World Forum for Harmonization of Vehicle Regulations

1958 Agreement – Consideration of draft amendments to existing Regulations submitted by GRE

Proposal for Supplement 42 to the 03 series of amendments to Regulation No. 37 (Filament lamps)

Submitted by the Working Party on Light and Light-signalling*

Sheet WT21W/1

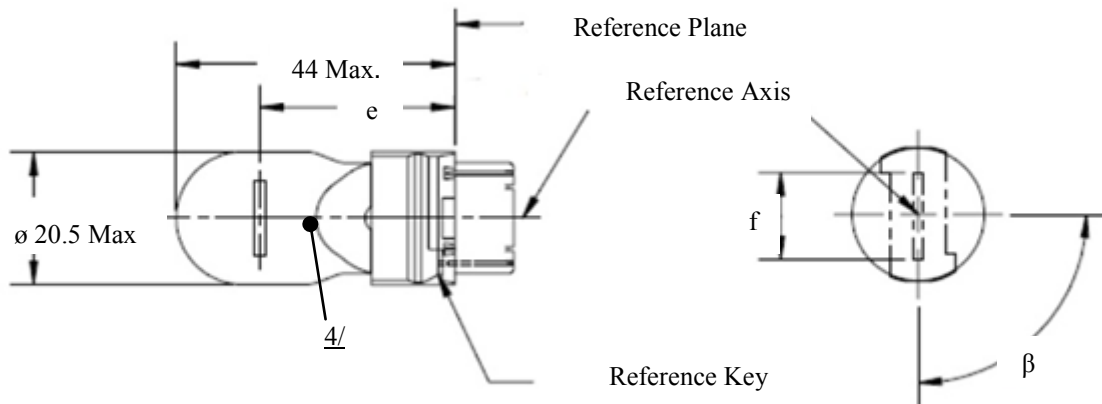
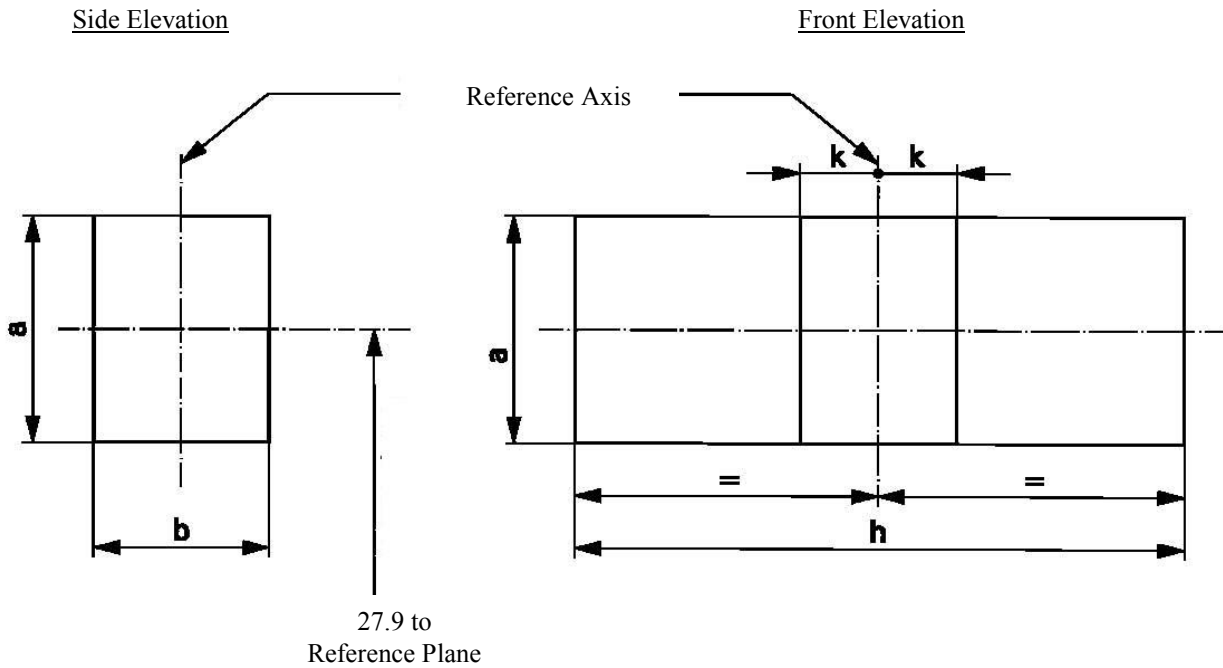
Insert new sheets WT21W/1 to 2 and WT21/7W/1 to 3 between sheet WR21/5W/1 and sheet WY2.3W/1, to read: (see next pages):

Dimensions in mm		Filament lamps of normal production			Standard filament lamp
		min.	nom.	max.	5/
e	12V		27.9 ^{3/}		27.9 ± 0.3
	24V	26.9	27.9	28.9	
f				7.5	7.5 + 0/ - 2
Lateral deviation ^{2/}	12V			^{3/}	0.0 ± 0.4
	24V			1.5	
β		75° ^{3/}	90°	105° ^{3/}	90° ± 5°
Cap: WT21W: WUX2.5x16d		in accordance with IEC Publication			(sheet 7004-[....]-1)
WTY21W: WUY2.5x16d		60061			(sheet 7004-[....]-1)
Electrical and photometric characteristics					
Rated values	Volts	12	24	12	
	Watts	21			21
Test voltage	Volts	13.5	28.0	13.5	
Objective values	Watts	26.5 max.	29.7 max.	26.5 max.	
	Luminous flux	WT21W	460 ± 15 %		
		WTY21W	280 ± 20 %		
Reference luminous flux at approximately 13.5 V:					White: 460 lm Amber: 280 lm

^{1/} The reference axis is defined with respect to the reference keys and is perpendicular to the reference plane.

^{2/} Maximum lateral deviation of the major (high wattage) filament centre from two mutually perpendicular planes both containing the reference axis and one containing the axis through the reference keys.

^{3/} To be checked by means of a "Box-System", sheets WT21W/2.

^{4/} The light emitted from filament lamps of normal production shall be white for category WT21W and amber for category WTY21W (see also note 5).

^{5/} The light emitted from standard filament lamps shall be white for category WT21W and white or amber for category WTY21W.

Example of the arrangement of the approval mark

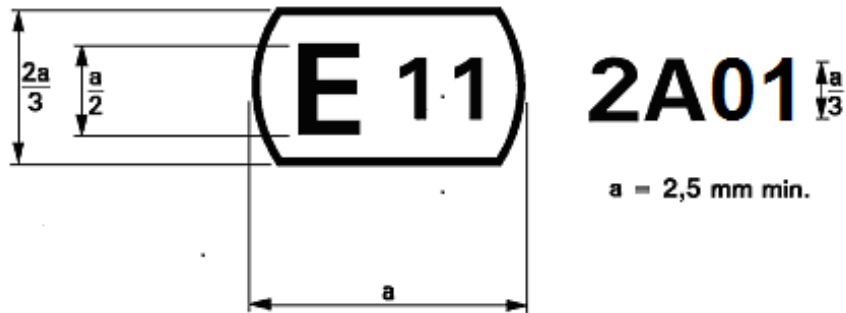
Annex 3, amend to read:

The above approval mark affixed to a filament lamp indicates that the lamp has been approved in the United Kingdom (E11) under the approval code A01.

The first character of the approval code indicates that the approval was granted in accordance with the requirements of Regulation No 37 as amended by the 02 and 03 (*) series of amendments."
